<b>Docket Number:</b>	14-AAER-02
<b>Project Title:</b>	Computer, Computer Monitors, and Electronic Displays
<b>TN #:</b>	204158
<b>Document Title:</b>	ITI/Technet Computer Presentations
<b>Description:</b>	PC's Cost Effectiveness/Technical Barriers
<b>Filer:</b>	System
<b>Organization:</b>	CEC/Harinder Singh
<b>Submitter Role:</b>	Commission Staff
<b>Submission Date:</b>	4/13/2015 4:11:02 PM
<b>Docketed Date:</b>	4/13/2015

**ITI/Technet Computer presentations**

# PC's Cost Effectiveness/Technical Barriers

## Dell Mainstream Desk Top Energy and Performance Trend

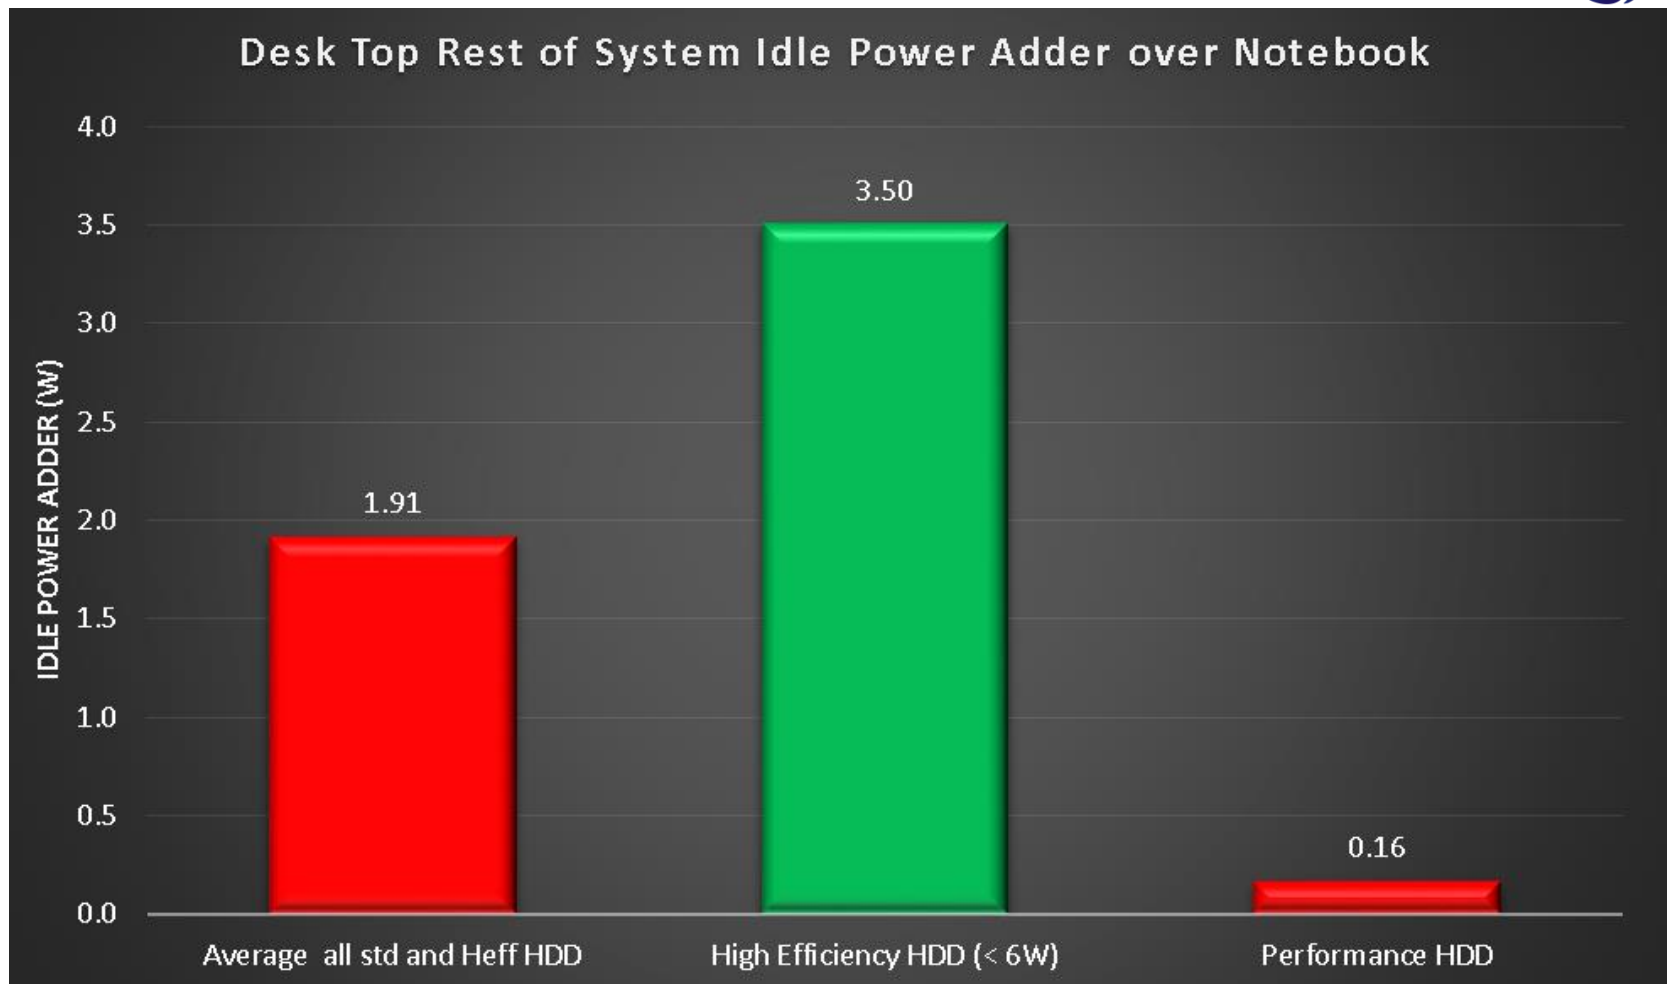
- Typical Desk top Energy and performance trends using different Usage Models
- 2014 Desk Top has a 78.4% reduction in Energy Use and 257% of the performance of a 2005 mainstream system
- Products got smaller, lighter and increased feature sets in same time frame

- PC Industry has a long history of performance gains Energy reduction and cost reductions
- Large variation in annual energy cost depending on Usage Model chosen
- Restricting performance will delay replacement cycles and prolong the life of older less efficient PC's in California market

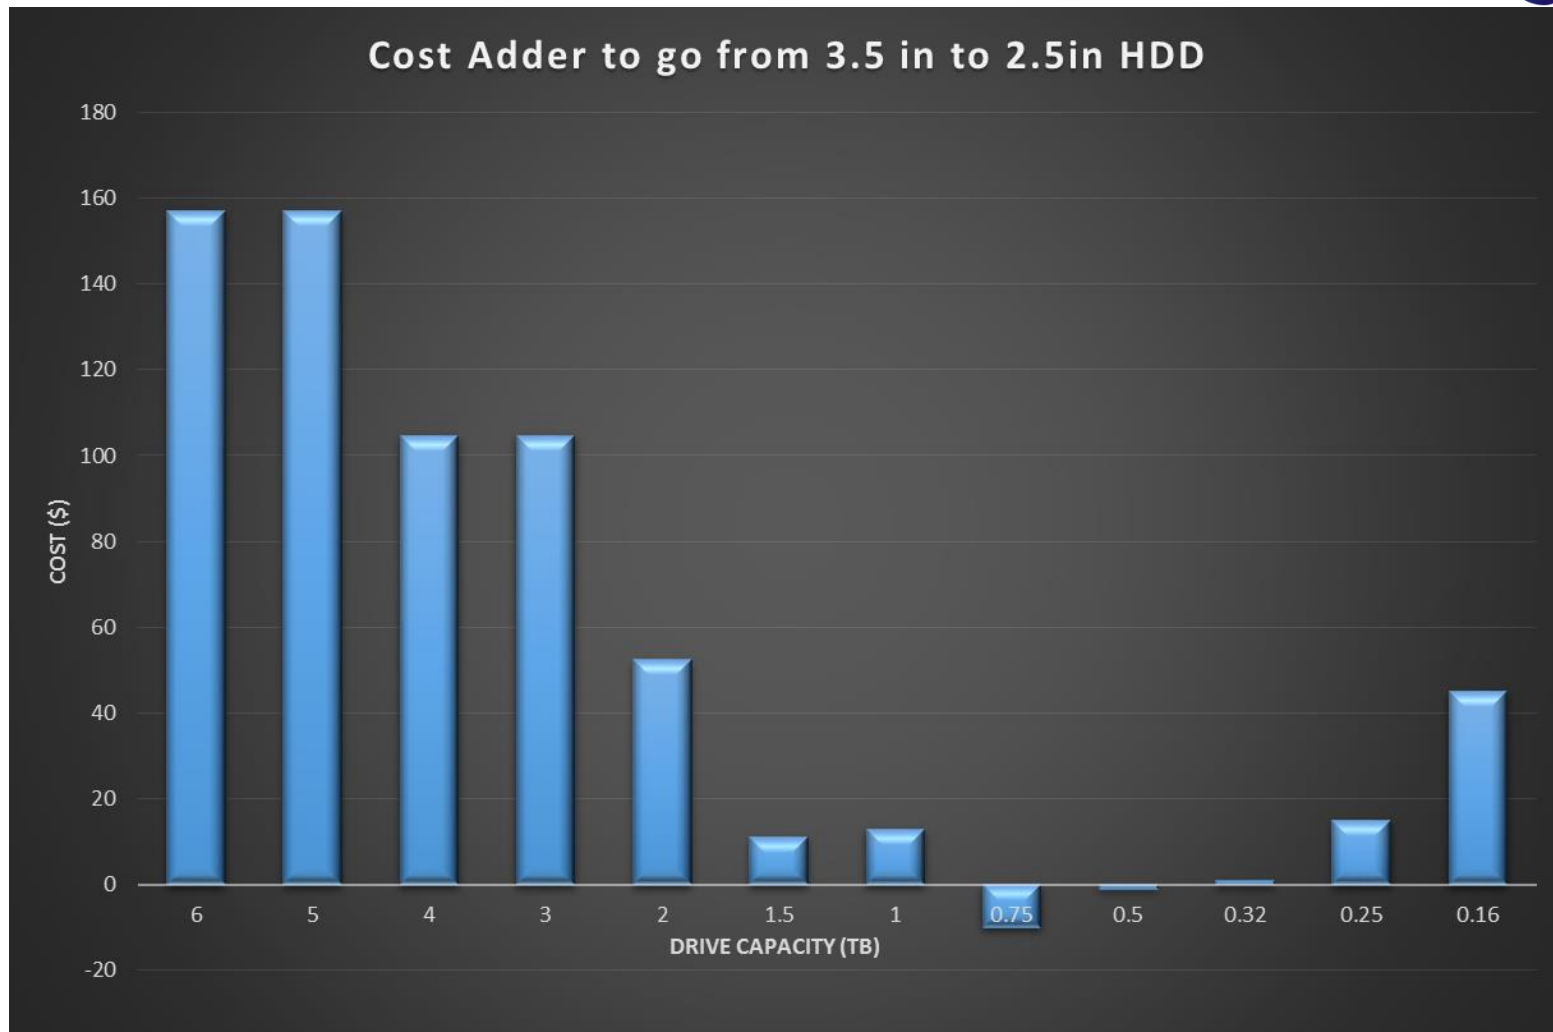
- The only way to allow non-notebook parts is to use High efficiency HDD's
  - Limited supply and reduced performance relative to standard HDD's
- Impossible to build a performance system with 3.5in performance HDD's without Mobile Parts

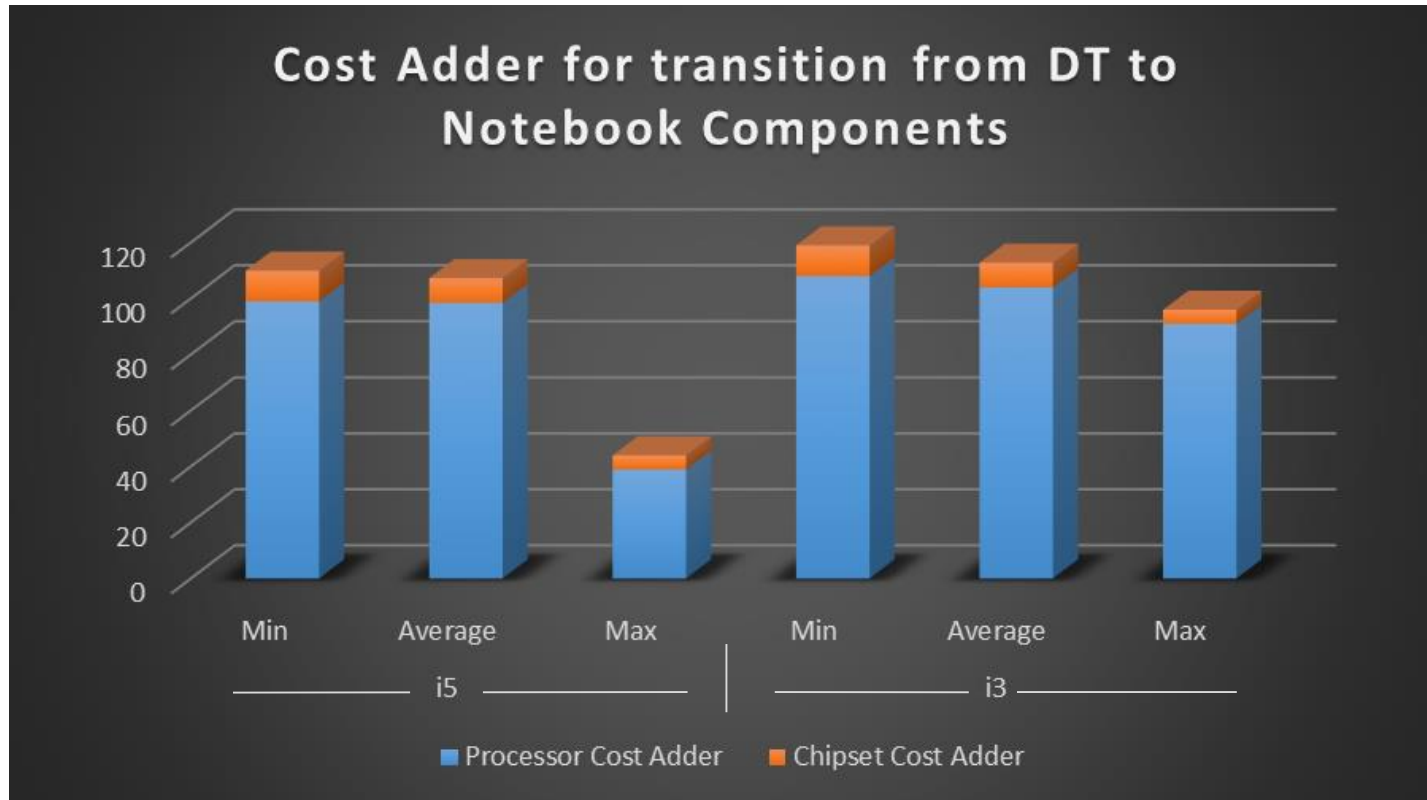
- Uses lowest cost advertised on Amazon.com for available HDD's
- Western Digital and Seagate current production drives considered
- Customers needing large Capacity will experience between 50 and 150.00 per unit cost increase
